**CONCORD HIGH SCHOOL
New High School Building**

BUILDING CODE OF AUSTRALIA 2022 & BCA ACCESS

100% SCHEMATIC DESIGN REVIEW

JUNE 2023

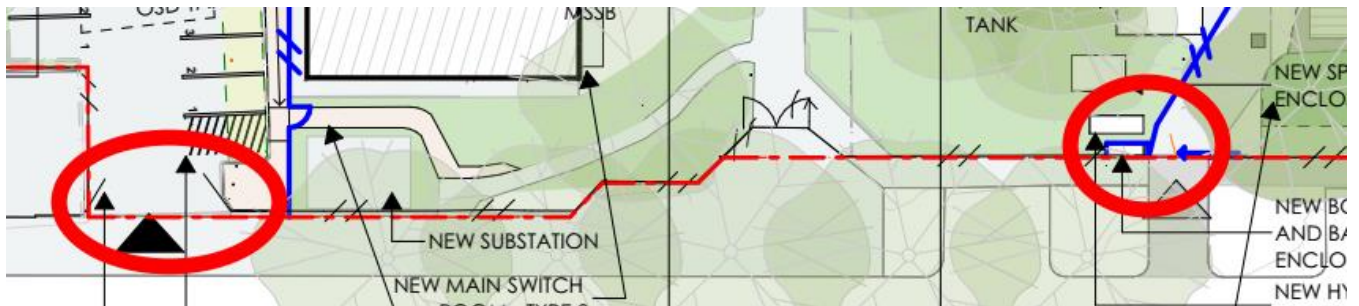
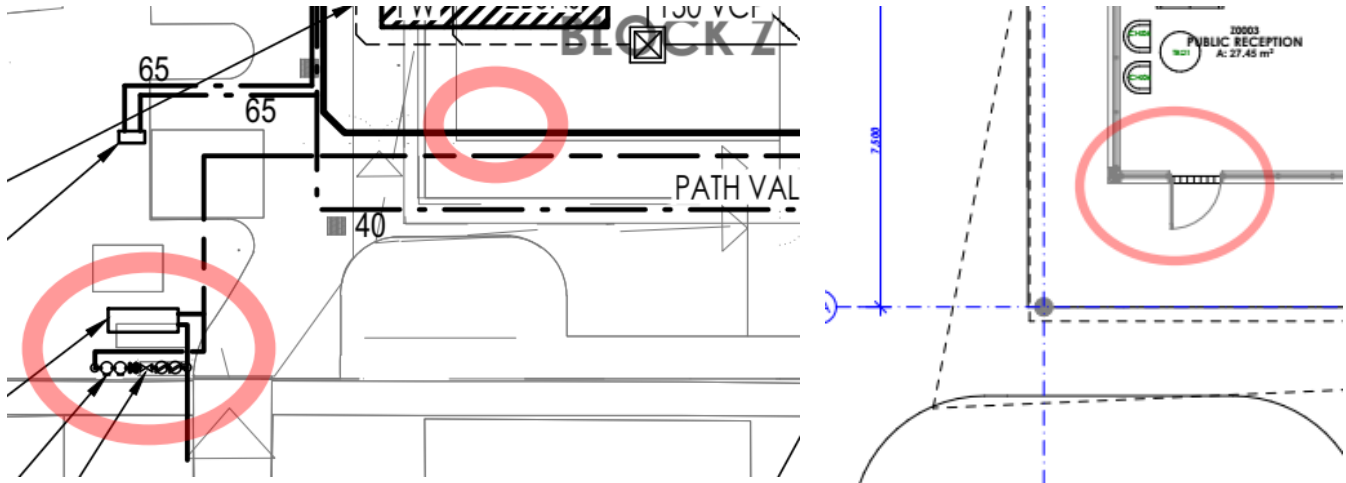
It appears that the fire hydrant booster is within sight of the principal pedestrian entrance to the proposed building but is not adjacent to the principal vehicle access. A fire engineering performance solution is proposed to address this non-compliance.

AS2419.1-2021 states that the Fire Hydrant Booster must also be protected from possible mechanical damage from vehicles. Provide details in the developed design drawings of this protection to the hydrant booster.

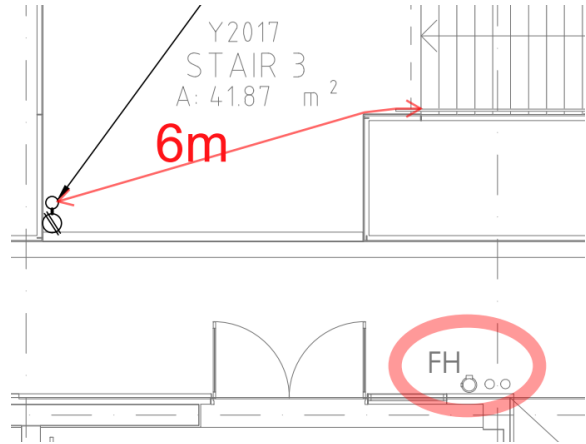
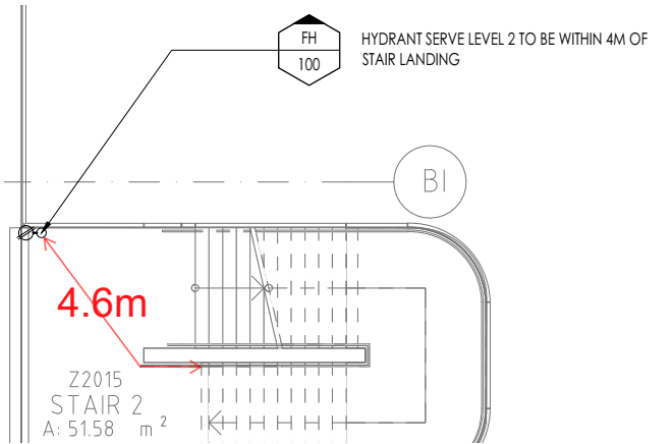
Currently the plans show that the internal fire hydrants are not within 4m of the exits and they show two locations for the fire hydrants and the drawings should be coordinated. The drawings note that the hydrants are to be within 4m of the stair landing but the requirement is that they need to be within 4m of the top of the descending flight of stairs as that is the exit.

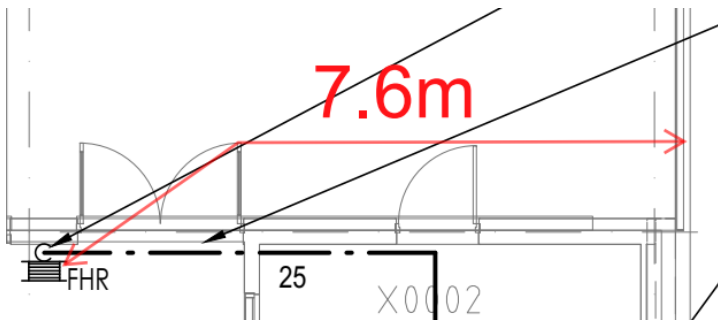
The FHR located by the northern exit from the gym is not located with 4m of the exit as the COLA roof means that the door is not the exit, the exit is the edge of the roof over the COLA. The FHR is required to be relocated to within 4m of the roof line.

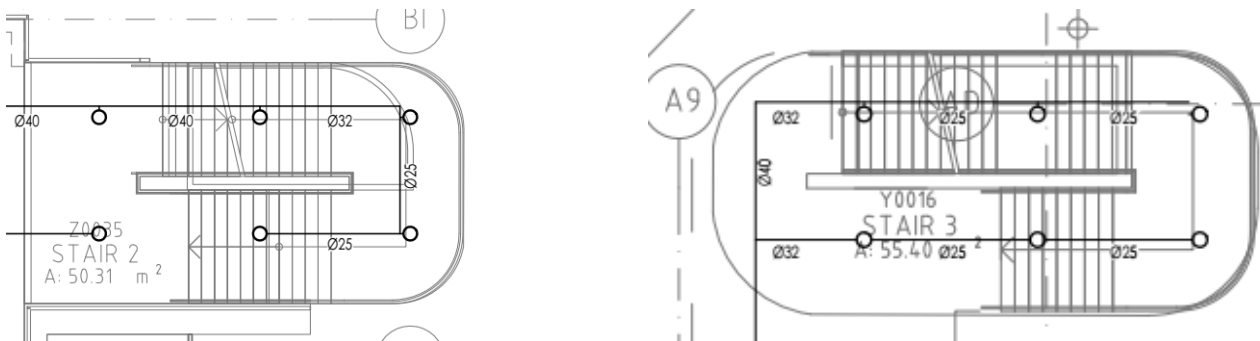
The typo in relation to the sprinkler booster be beside the vehicle entry should be modified on the next issue of the fire services drawings.

The sprinkler drawings are required to clarify that sprinklers are to be provided to the underside of the bottom flights of the two external stairs.

The sprinkler drawings are required to clarify that sprinklers are to be provided to the underside of the roof over the top of Stair 2.

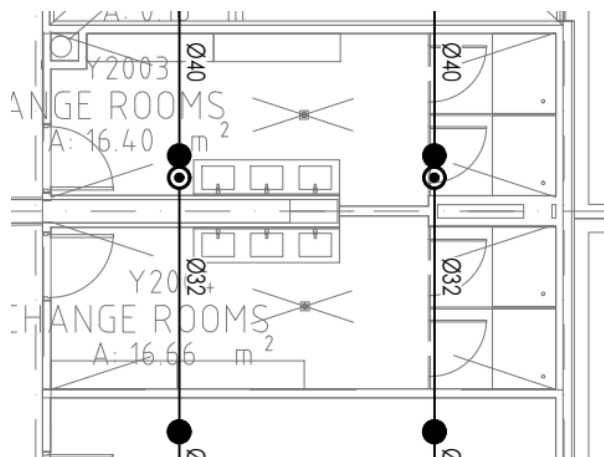
The next issue of the drawings are required to clarify the location of some of the sprinklers as they are not located in the room or space which they are intended to be located within.

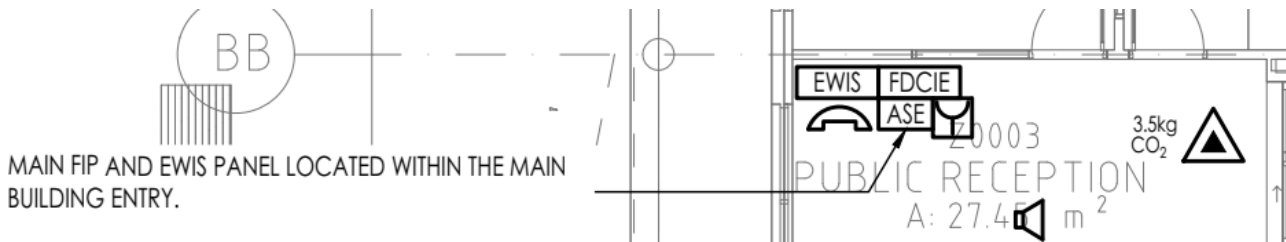
The FIP is required to be located at the designated building entry point which is the primary occupant entry point for the building as shown on the design drawings.

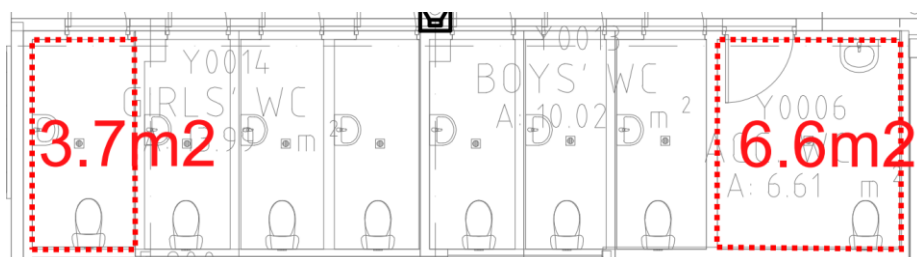
The western most girls toilet and the accessible wc on the ground floor have a floor area of more than 3.5m² and are required to be provided with detection.

The next issue of the drawings are required to clarify the location of some of the detectors as they are not located in the room or space which they are intended to be located within.

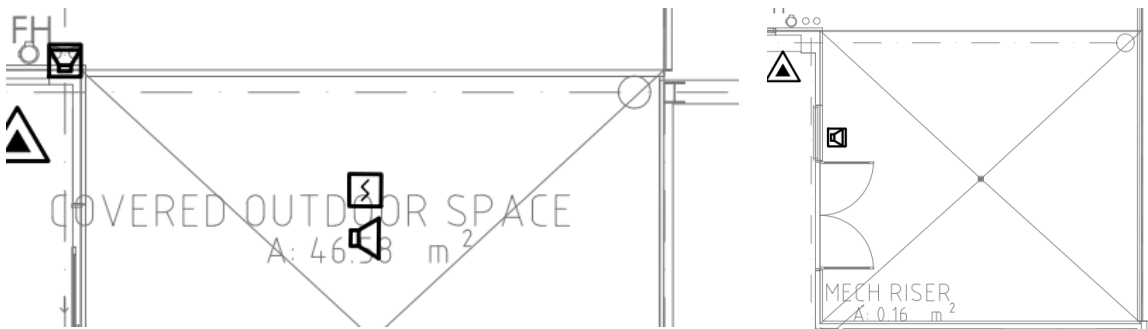
The fire services designer should confirm if smoke detectors are suitable in the level 1 outdoor areas rather than thermal detectors due to false alarms from the external areas. The designer should also confirm if detection is required on the level 2 outdoor area as it may not be open enough to fall under the concession in clause 3.28(c) of the standard.

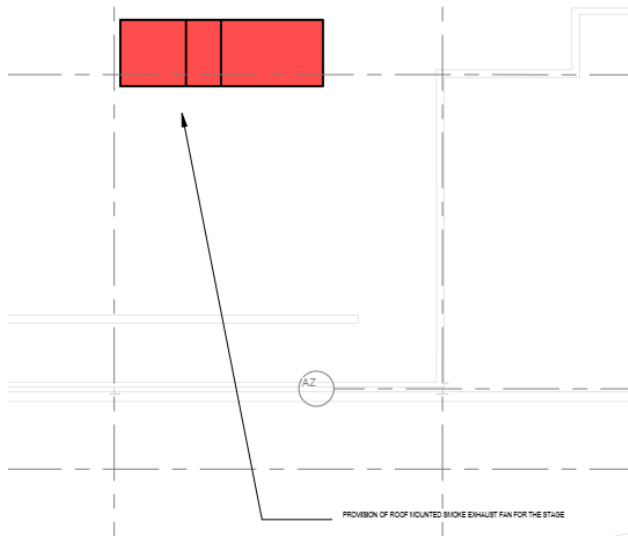
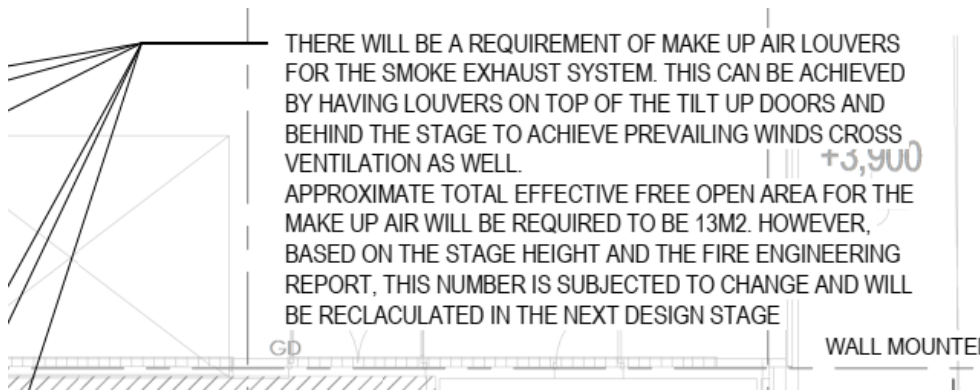
It is noted that M2002 states that louvers are required behind the stage for make up air but these are not shown on the architectural elevations.

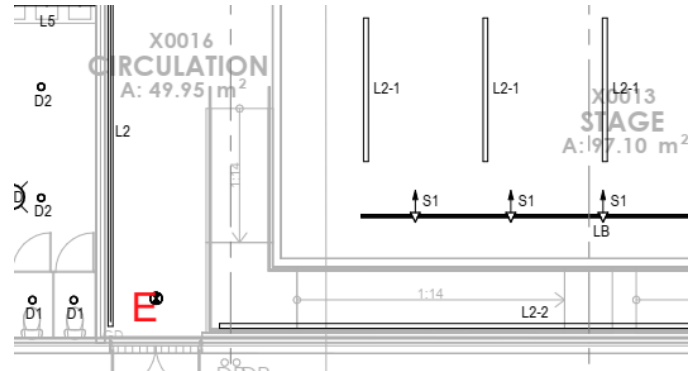
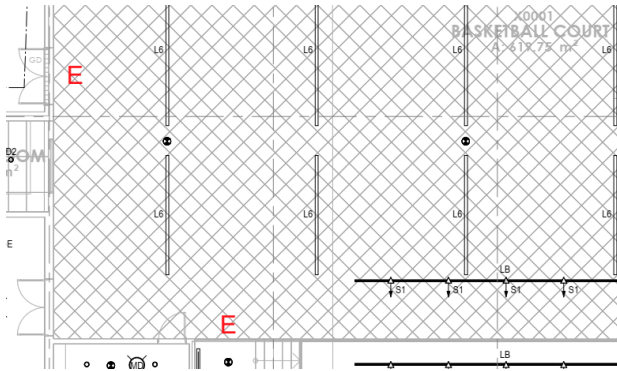
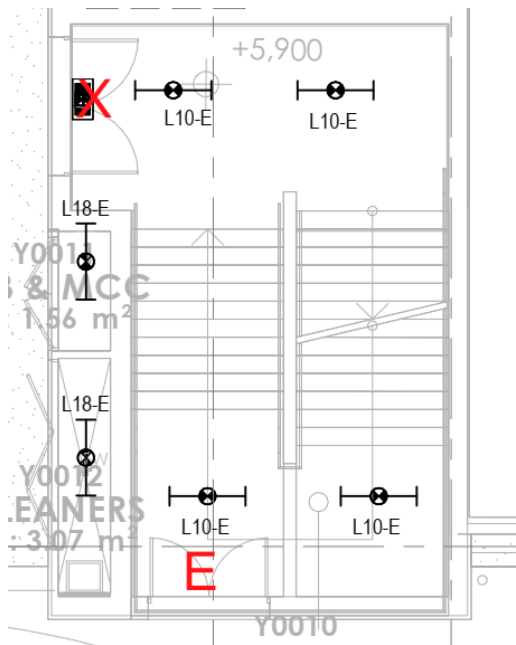
The exit sign at the base of Stair 1 over the double doors opposite the admin area is to be deleted and an exit sign if required to be located over the door opening from the southern side of the stairs to the outside.

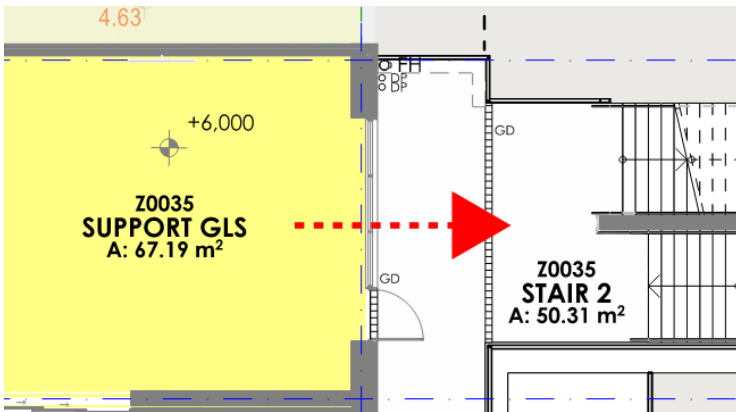
The window to Z0035 on ground level open to the enclosed corridor facing the egress stair and do not provide compliant natural light.

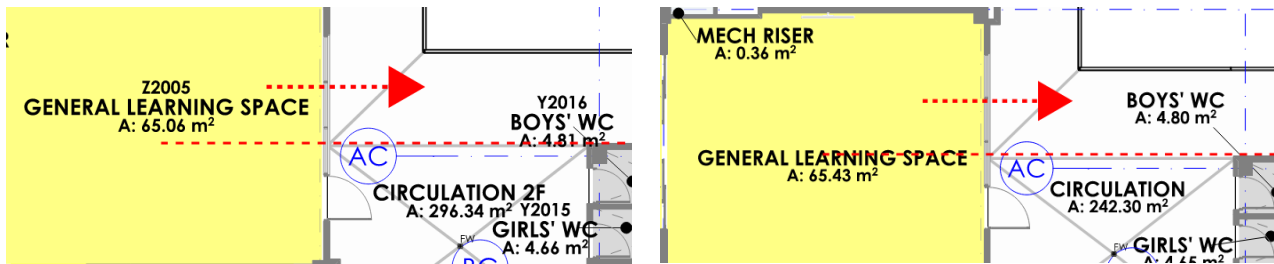
Only a portion of the windows in room GLS Z2005 & Z3005 on level 2 and 3 shown below face an open walkway and can provide compliant natural light. Provide details of the glazing for assessment.

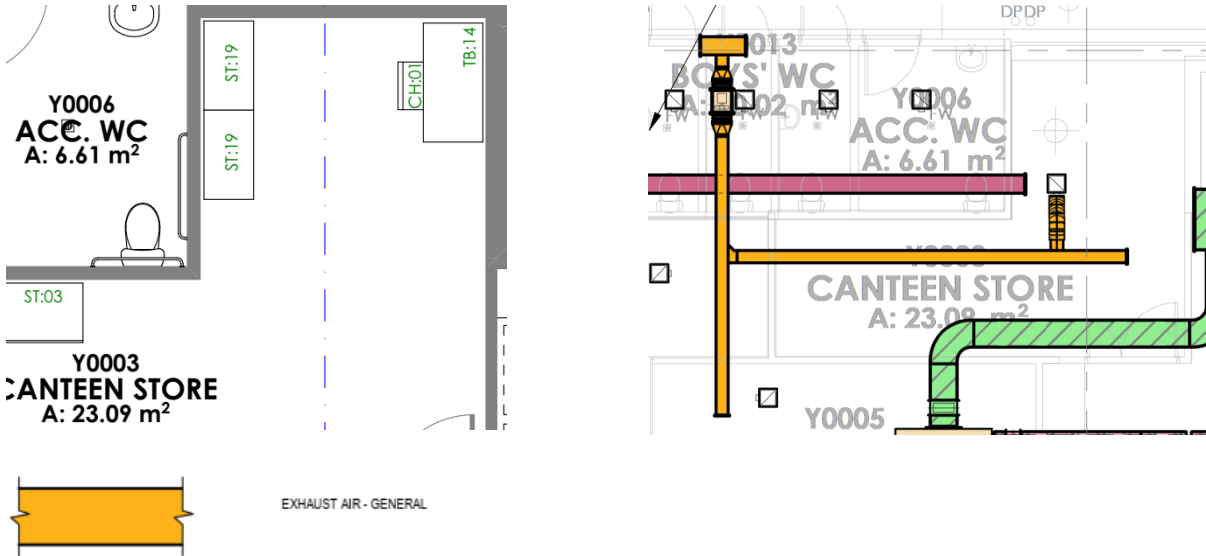
The ground level canteen store is provided with a desk so it is assumed that it is also the office for the canteen staff and as such is required to be provided with ventilation however currently only exhaust air is provided.

The developed design drawings are required to show how make up air is provided to the toilets provided with mechanical ventilation. See example below.

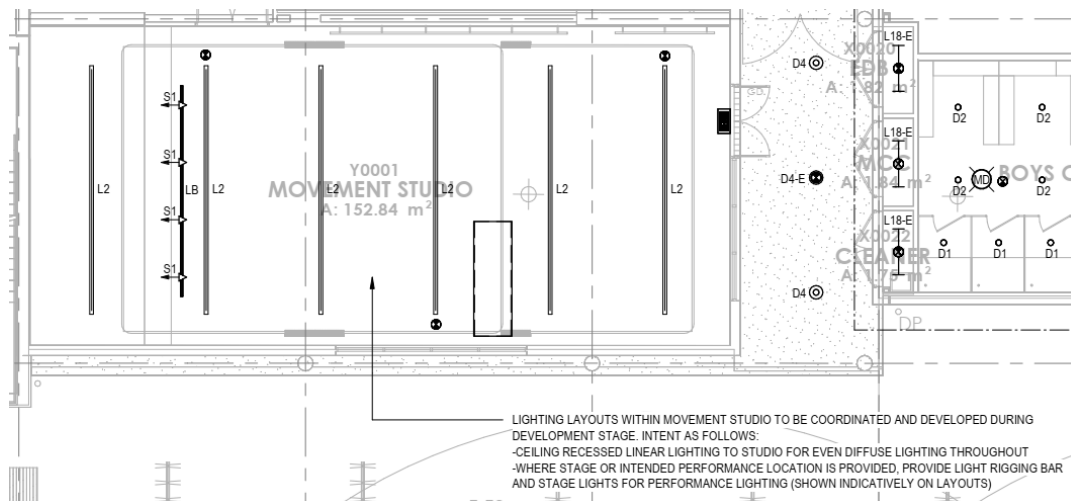
It is assumed that the rigging bar mentioned on drawing E3000 for the movement studio is not a rigging loft. If it is then the BCA requirements of NSW Part I4 (and I1) will apply to the room. Provide further details of the rigging bar.

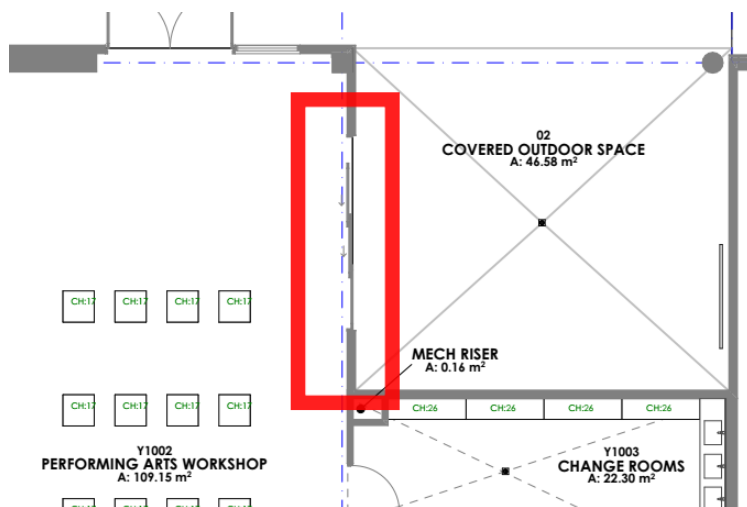
The sliding door on level 1 from the performing arts workshop to the outdoor space is required to be self closing. Please confirm if the proposed sliding door is an auto door and if not replace it with a self closing swing door.
